Addendum No.: 3

Date Of Addendum: 5/21/2019

Rooftop A/C & Roof Replacement
300 Corporate Place
Rocky Hill, CT
BI – 2B – 387

ADDENDUM #3
**ROOF TOP A/C UNIT AND
 ROOF REPLACEMENT**
 300 CORPORATE PLACE, ROCKY HILL, CT
 Project No. BI-2B-387

MAY 17, 2019
SKP-01
 DRAWING REF: PD-103

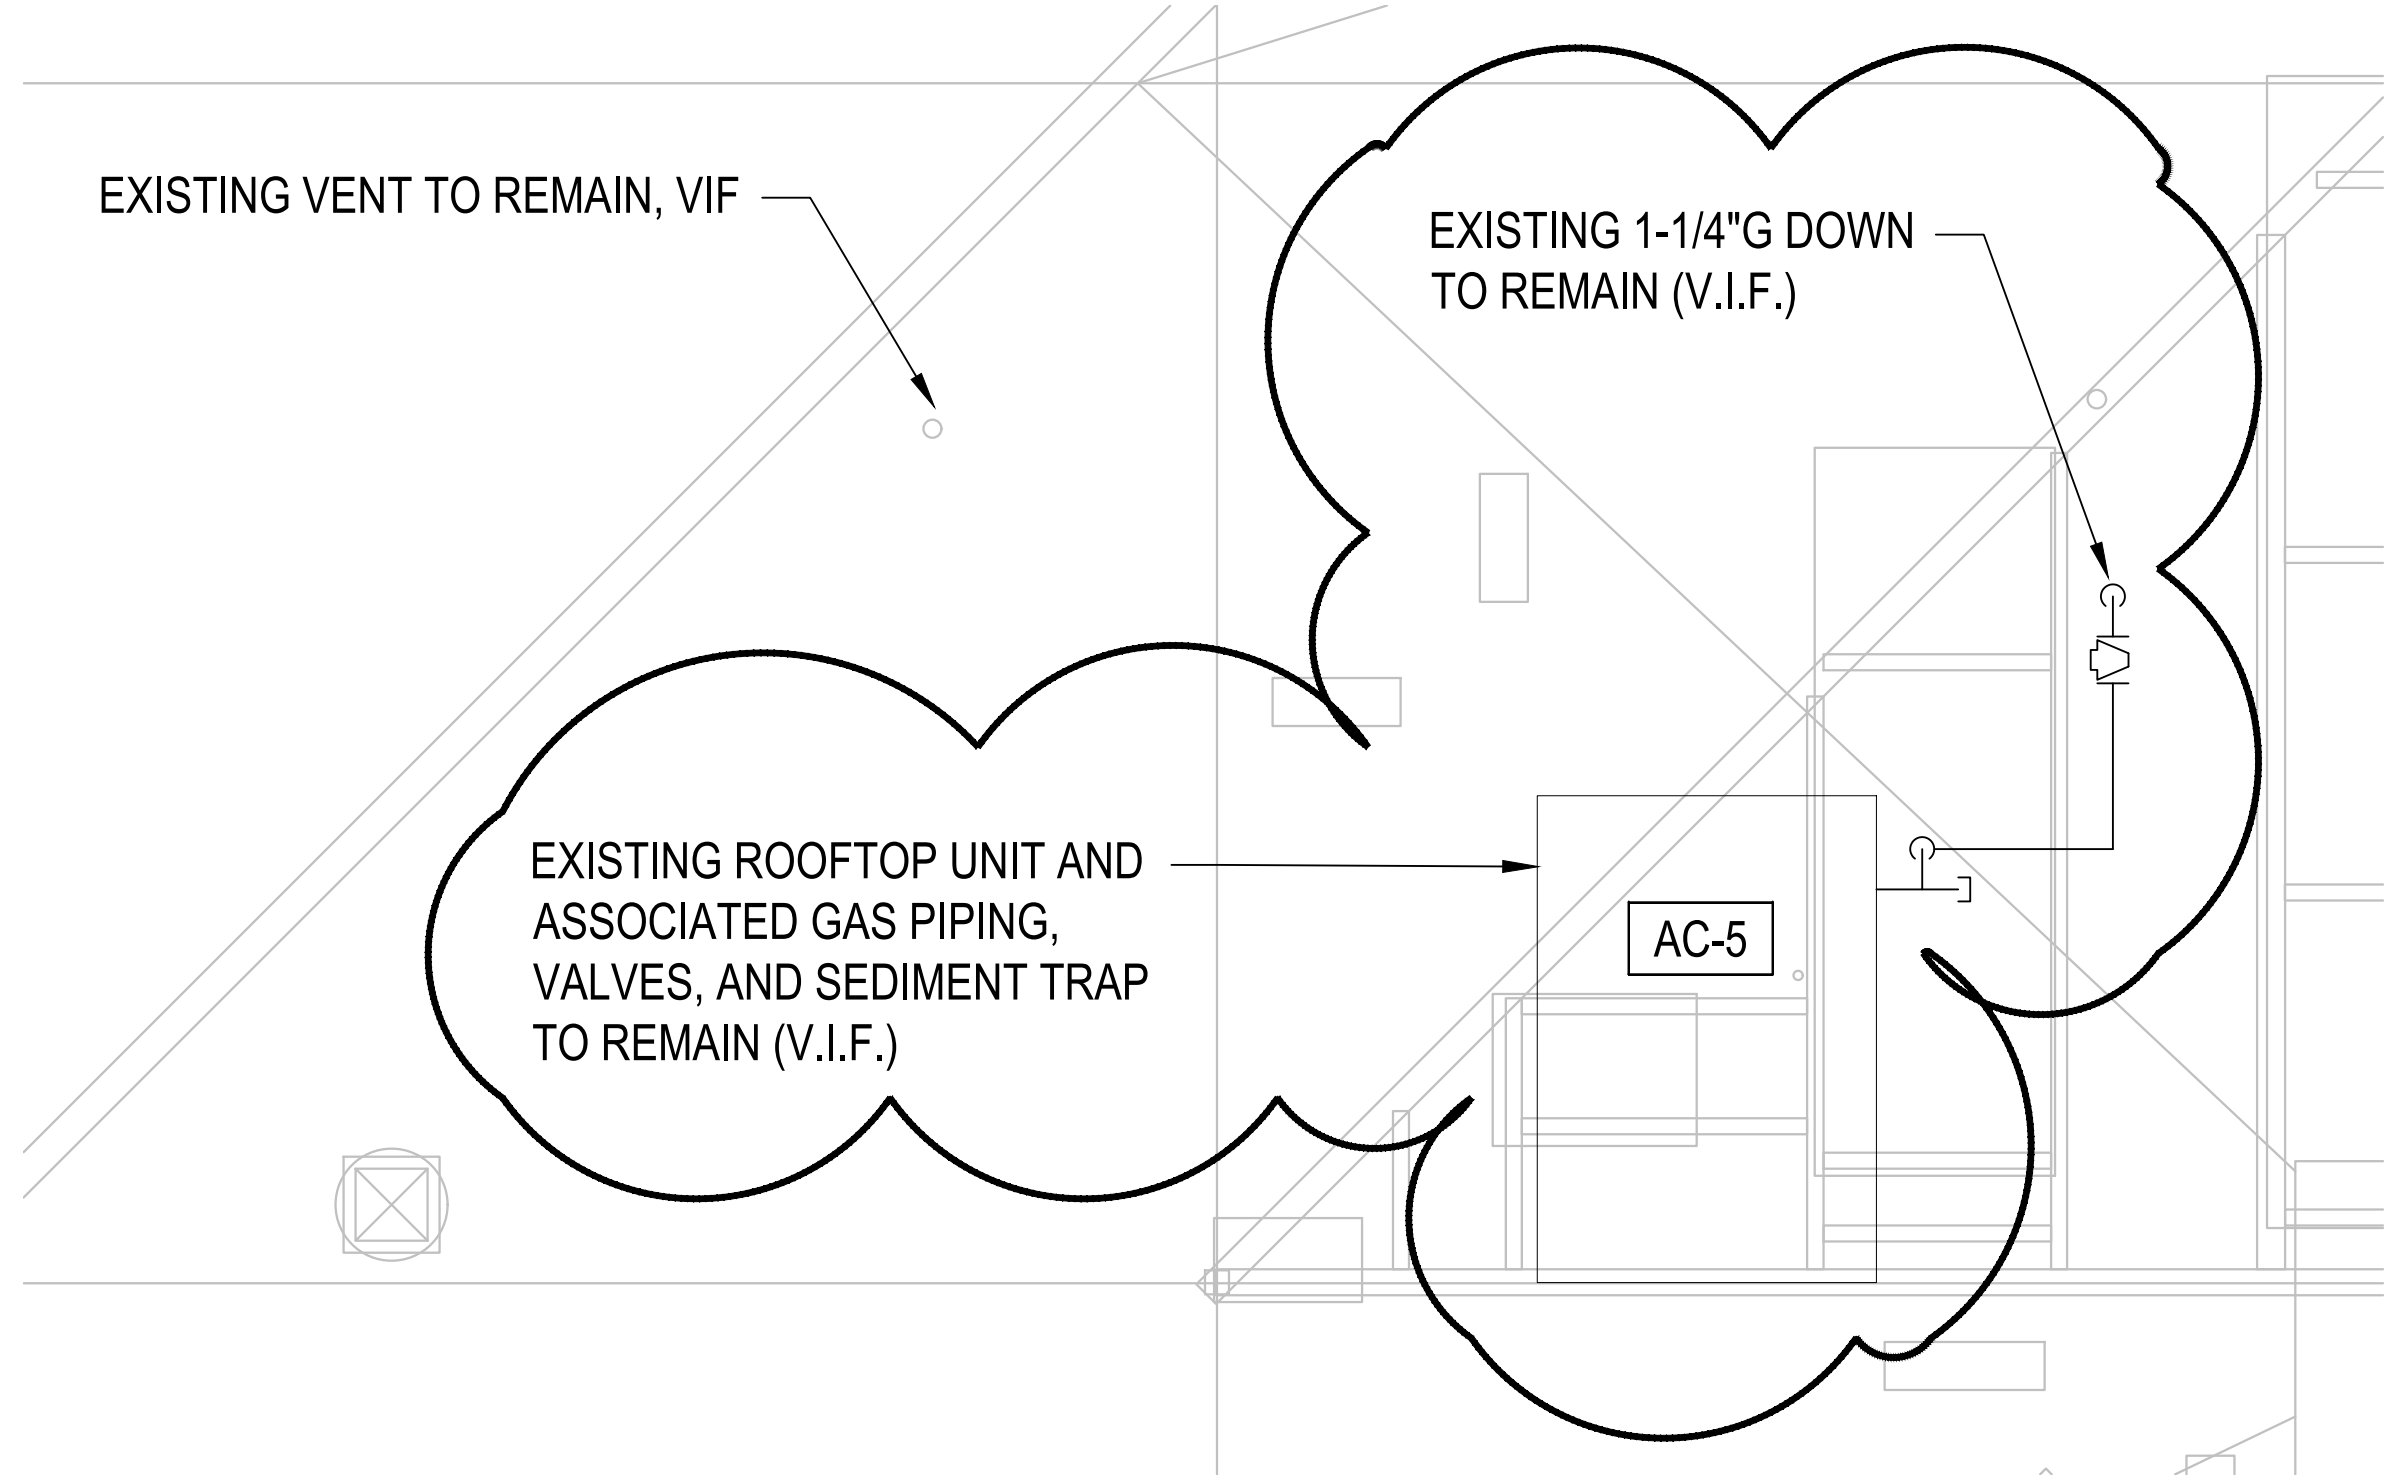
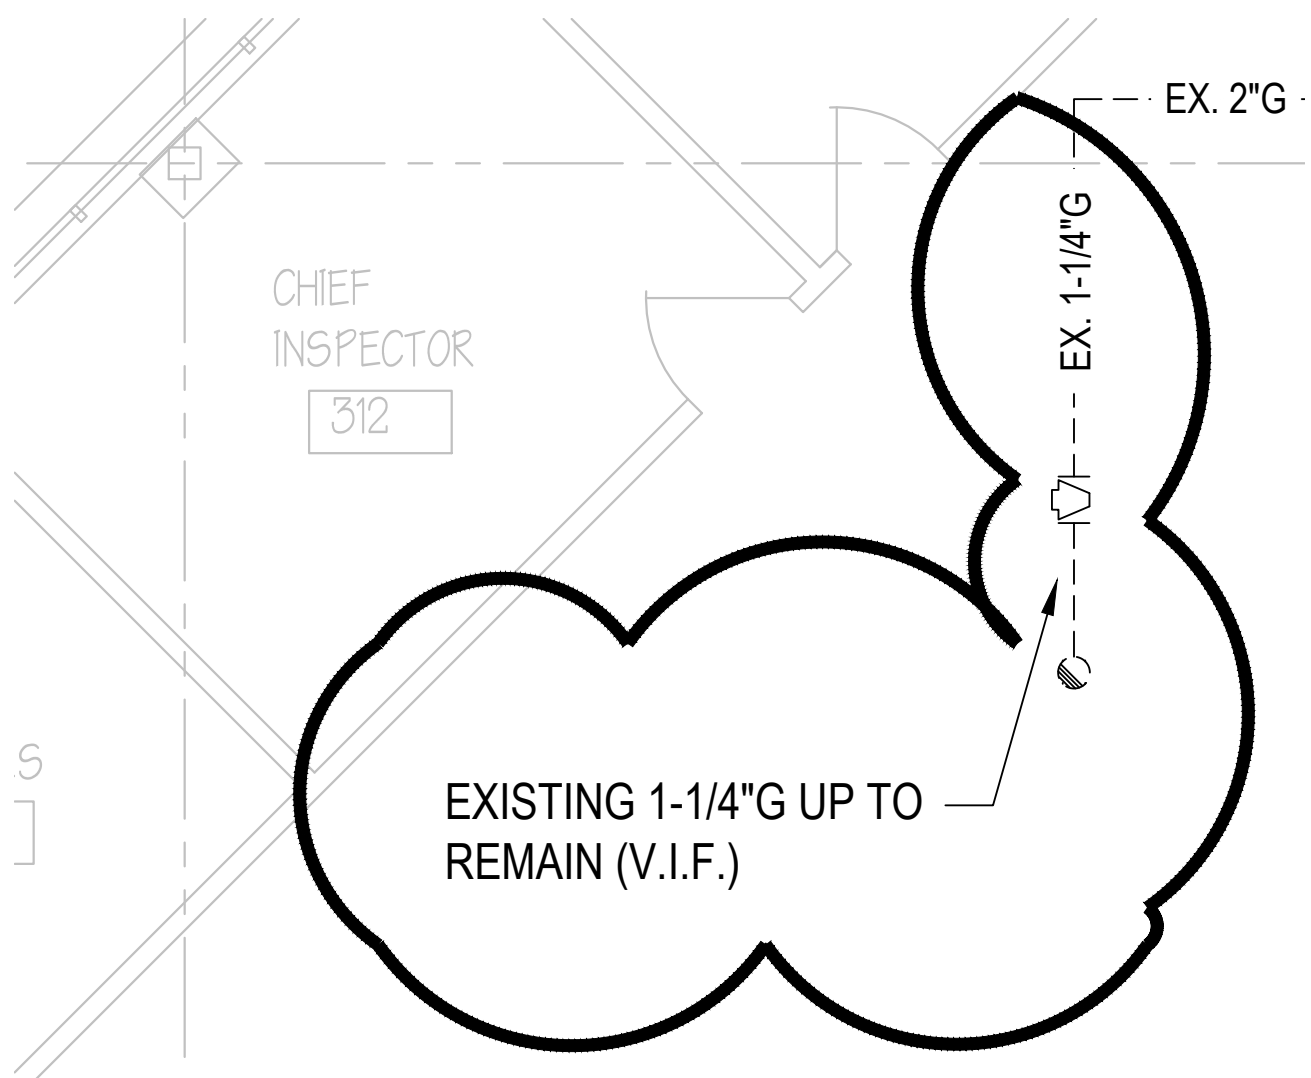
Contract Drawings MD-104, M-101, M-104, ED-104, E-104, E-401, PD-103, PD-104, P-103, P-104, P-204
Revise Contract Drawings with attached sketches SKM-02, SKM-03, SKM-04, SKE-03, SKE-04, SKE-05, SKP-01, SKP-02, SKP-03, SKP-04, SKP-05 and SKP-06 for removal of all work associated with rooftop unit AC-5.
AC-5 is being replaced under BI-2B-452 – Coordination between project BI-2B-387 and BI-2B-452 may be required.
